SITE LAYOUT PLAN
7537 20TH AVENUE

PART OF THE SW 1/4, SECTION 15, T6N, R13W, GEORGETOWN TOWNSHIP, OTTAWA COUNTY, MICHIGAN

This letter is being provided to revise the general notes regarding the Special Land Use Application submitted by 7537 20th Ave and include the special conditions that were submitted with the application as an attachment. Special condition #4 was revised to provide additional details.

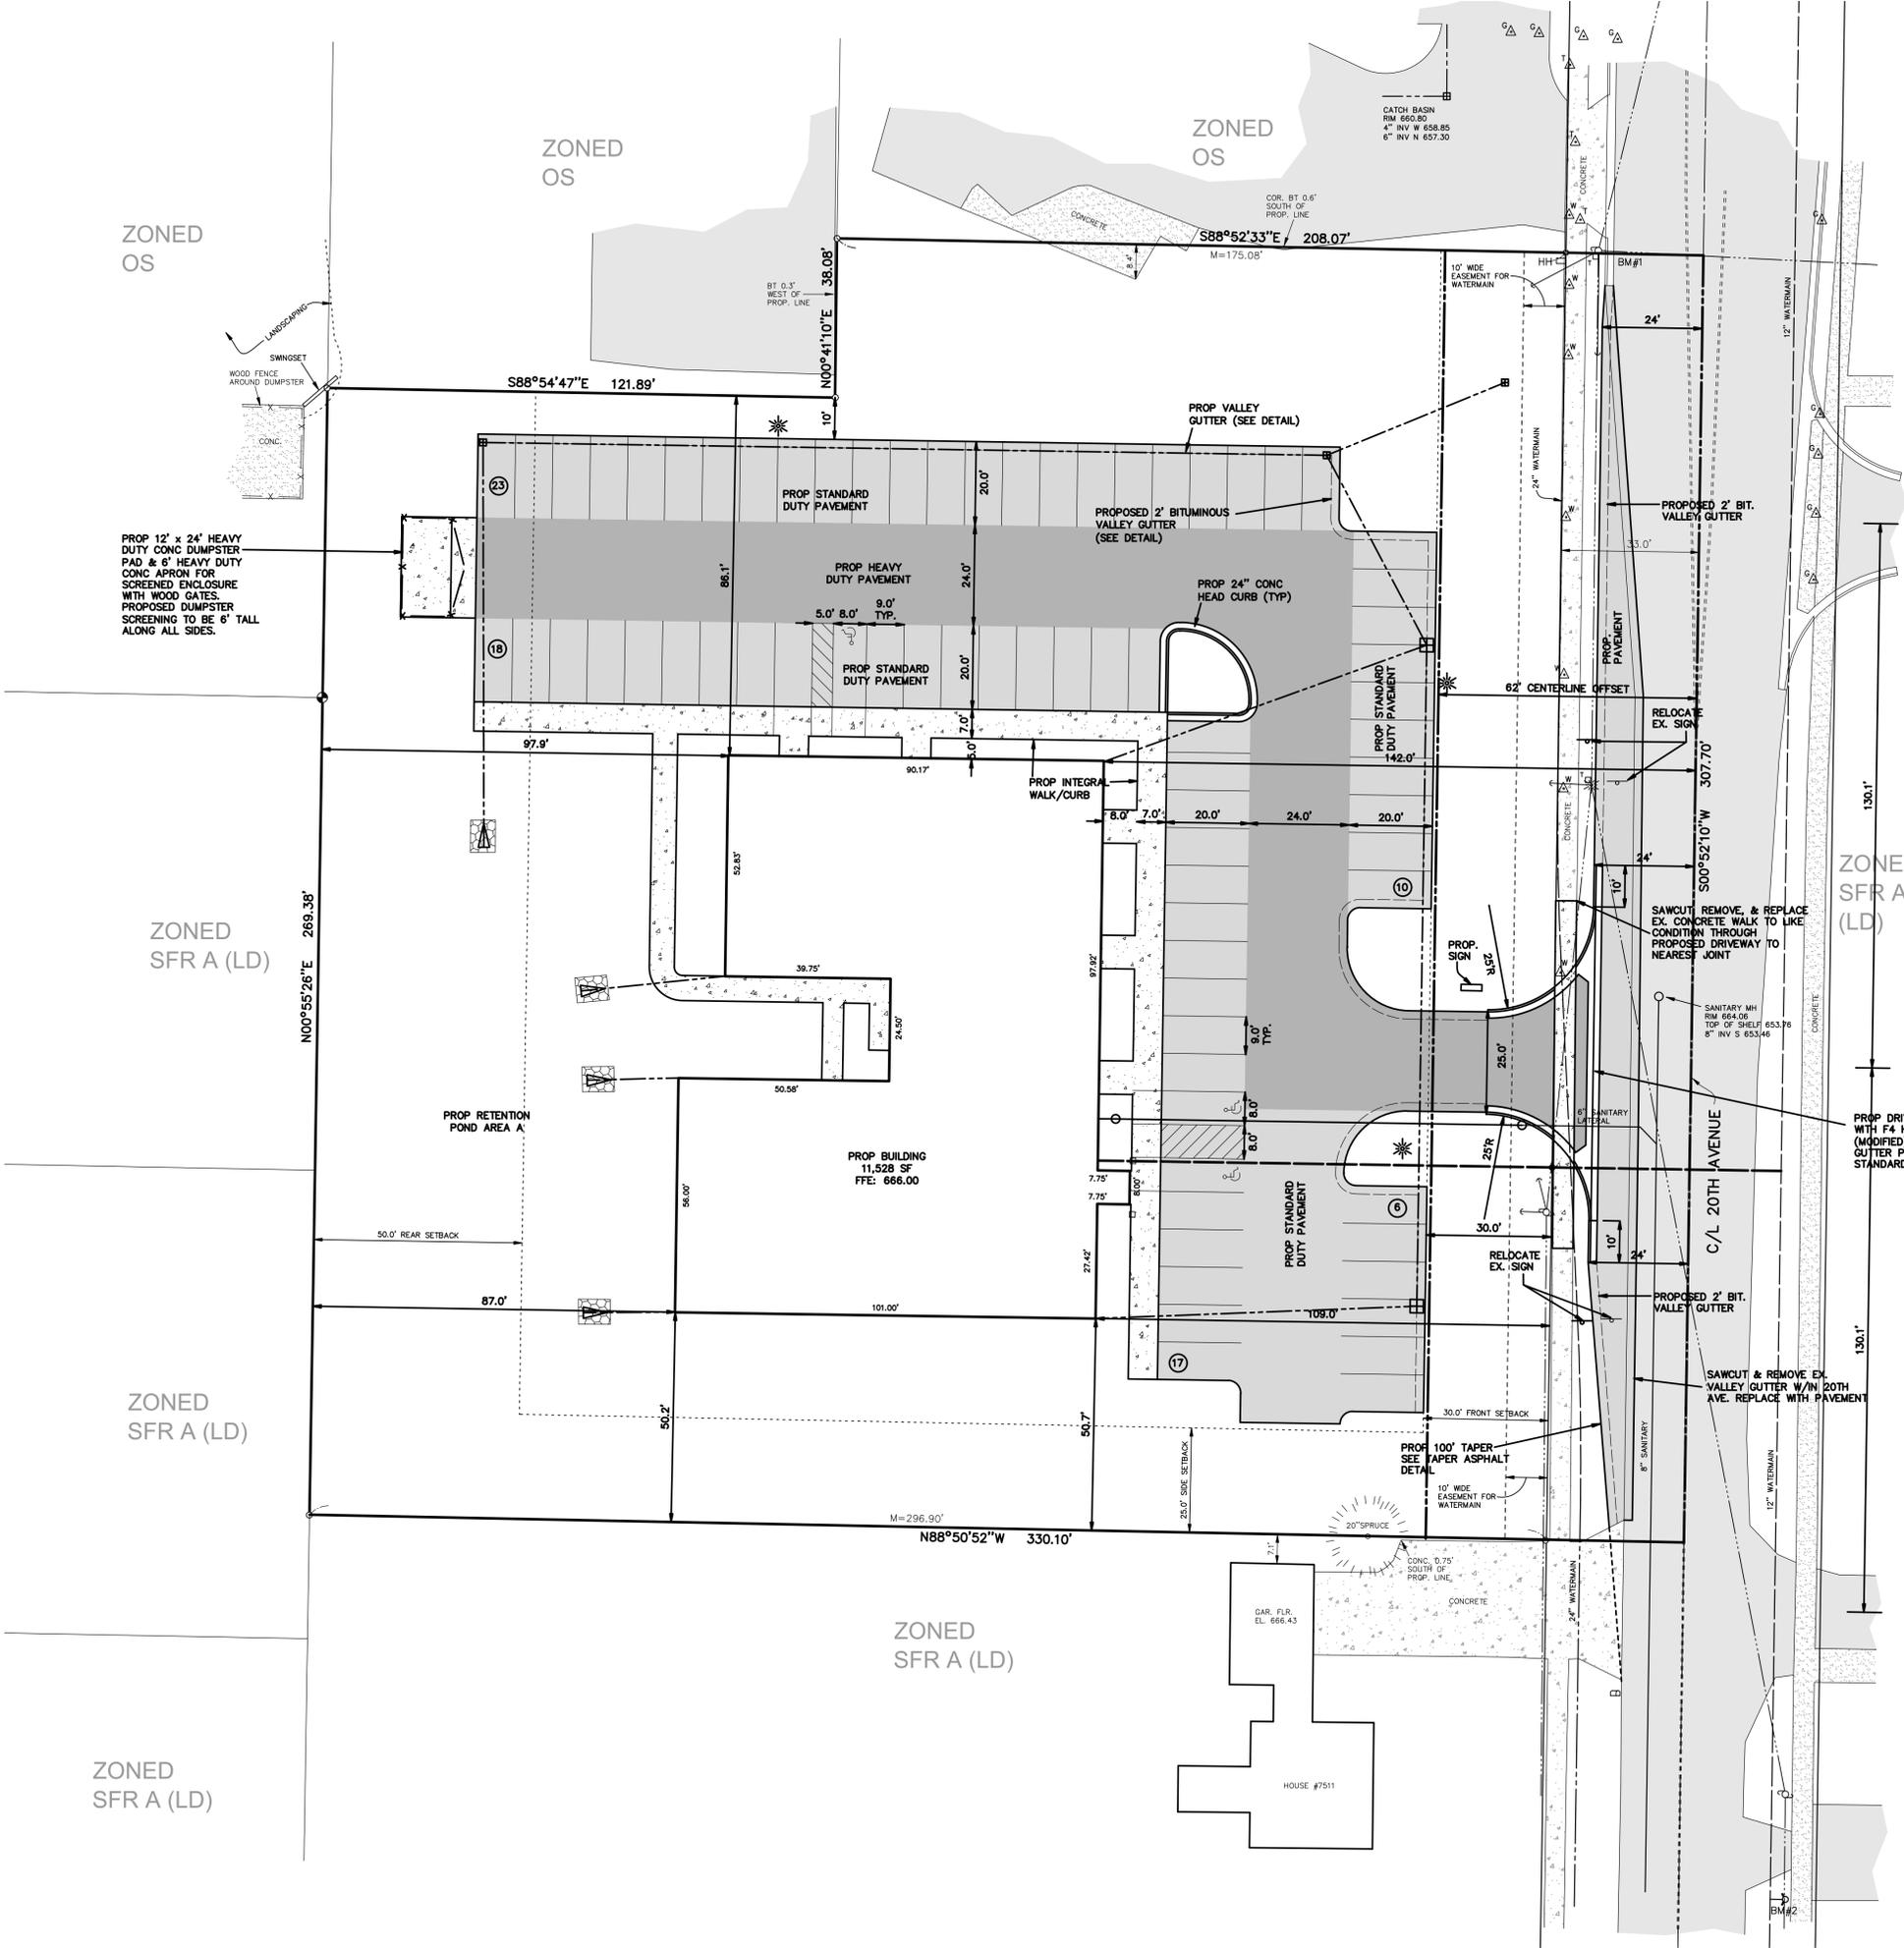
04/17/25	REVISED PARKING NOTES	JVD
09/20/24	REV. UTILITIES PER DPW	JVD
09/12/24	REV. DETENTION DESIGN	JVB
08/26/24	REVISED PER DEVELOPER	JVD
08/18/24	REVISED PER OCWR	JVD
08/15/24	REVISED PER OCWR	JVD
04/15/24	REVISED STORMWATER & PARKING LOT	JVD
03/13/24	REVISED DRIVEWAY PER OCWR	JVD
03/07/24	REVISED BUILDING LAYOUT	JVD
DATE	REVISION	BY

The parking calculation has been modified as the following:

5 PARKING:
 REQUIRED:
 RESTAURANT USE: 36 (2,500 UFA / 70 = 36 REQUIRED)
 DENTIST OFFICE: 42 (14 EXAM ROOMS * 3 = 42 REQUIRED)
 COUNSELING OFFICE: 1660 SF (1660 GFA / 300 = 6 REQUIRED)
 VACANT TENANT (IF OFFICE USE PROPOSED): 1320 SF (1320 GFA / 300 = 6 REQUIRED)
 TOTAL: 36 + 42 + 6 + 6 = 89 SPACES
 25% PARKING REDUCTION PER SEC 23.6 (K) 89 * 0.75 = 67 SPACES

TOTAL PARKING REQUIRED = 67 SPACES (3 ADA)

PARKING PROVIDED = 74 SPACES (3 ADA)
